R E M A R K S

In response to the Examiner's comments in the Final Rejection:

Annotated sheet Showing Changes

FIG. 4

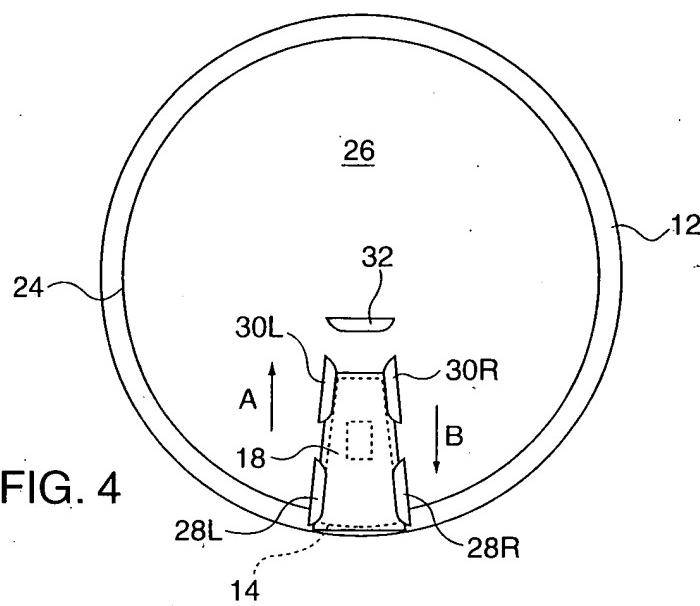
The Specification has been amended at Page 5 to clarify that FIGURE 4 shows an underside view of the closure lid of FIGURES 1-3 helpful in an understanding of the invention. The Specification has also been amended at Pages 7 and 8 with respect to FIGURE 5, indicating that the panel door freely slides between the pair of grooves and the underside of the closure lid. (This is carried through in the submitted Amendment to the Drawings.)
